DRAWINGS AND DESCRIPTION OF PROPOSED CHANGES

- any scaling from this drawing other than by the local planning authority solely for the purposes of the planning application to which it relates	
LOCATION	
job title	
TOTTENHAM HALE CENTRE ISLAND SITES

drawing title / location	
PROPOSED L14-17 FLOOR PLANS	
drawn by	checked
JS	AM
scale	status
1 : 250@A1, 1 : 500@A3	FOR APPROVAL
drawing number	revision
TH-IS_ZZ_001_A_16092_(P00)_P114	P04

3.4 BUILDING 1 UPPER FLOORS - FOURTEENTH TO SEVENTEENTH FLOOR

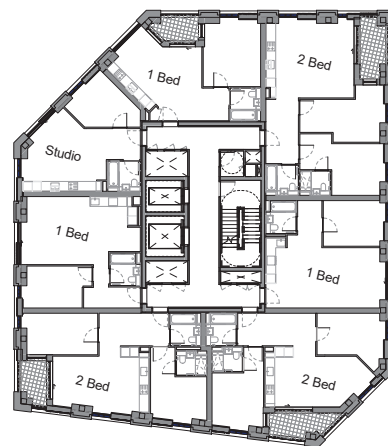
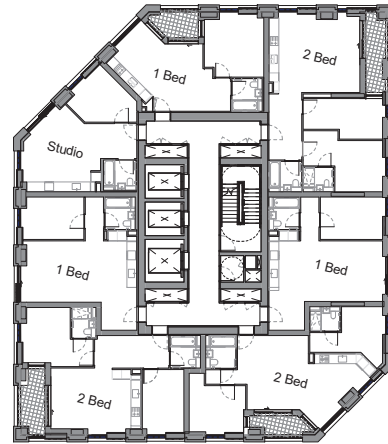
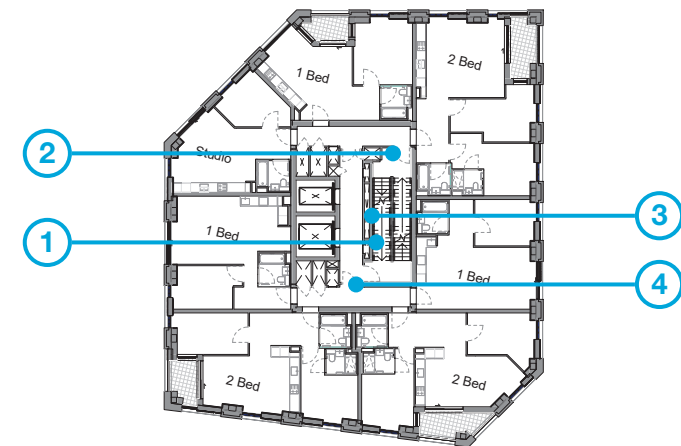
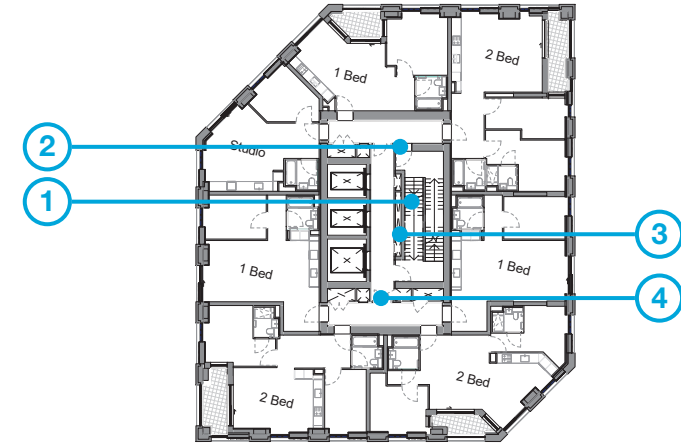
1. A second fire escape stair has been added between ground floor to upper levels.
2. Due to the addition of the second stair, the position of the access to the stairs has changed to resolve level changes across all floors.
3. Service risers have been relocated within the core following the addition of the second staircase.
4. Additional doors have been added within the communal corridors to comply with the latest fire strategy.

3.2 BUILDING 2 UPPER FLOORS - FOURTEENTH FLOOR

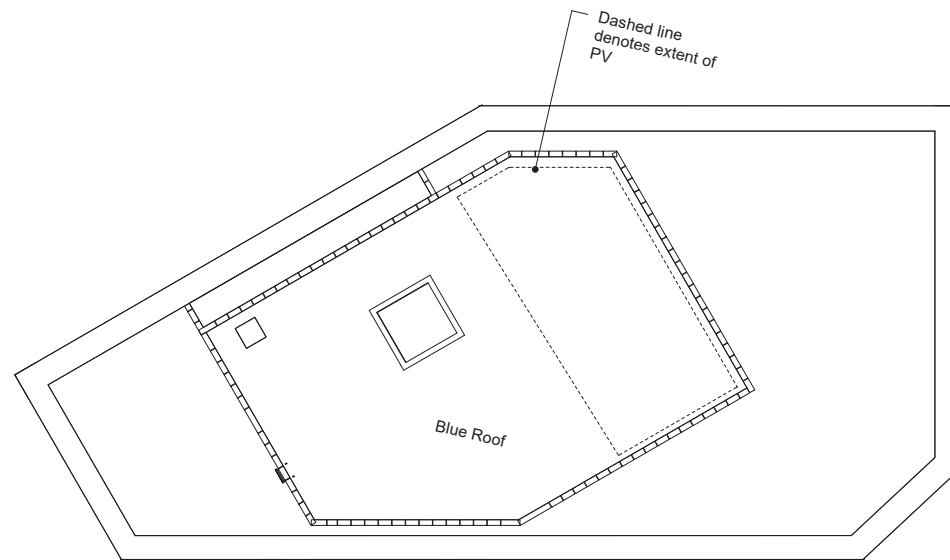
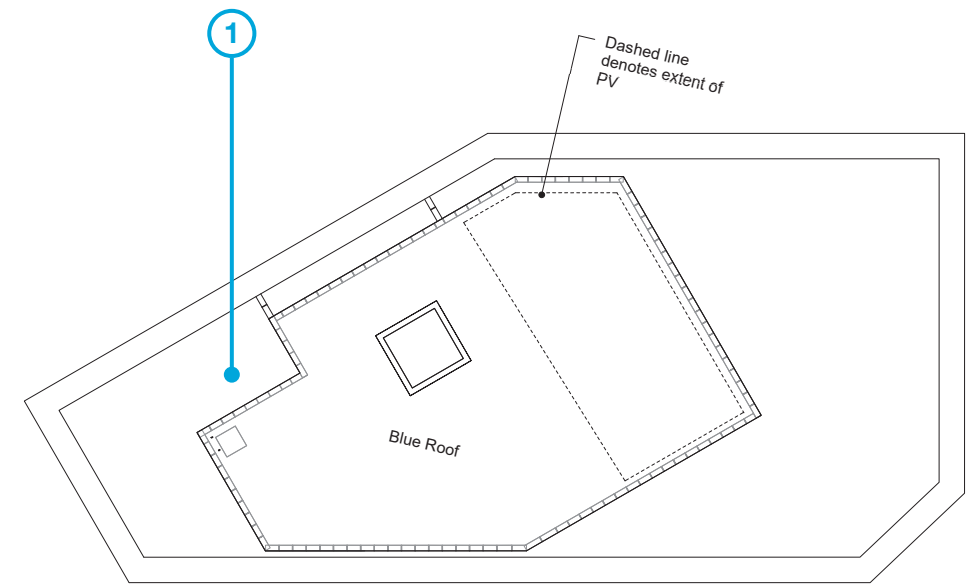
1. Updated roof plan to capture the rotation of the stair on the lower floors.
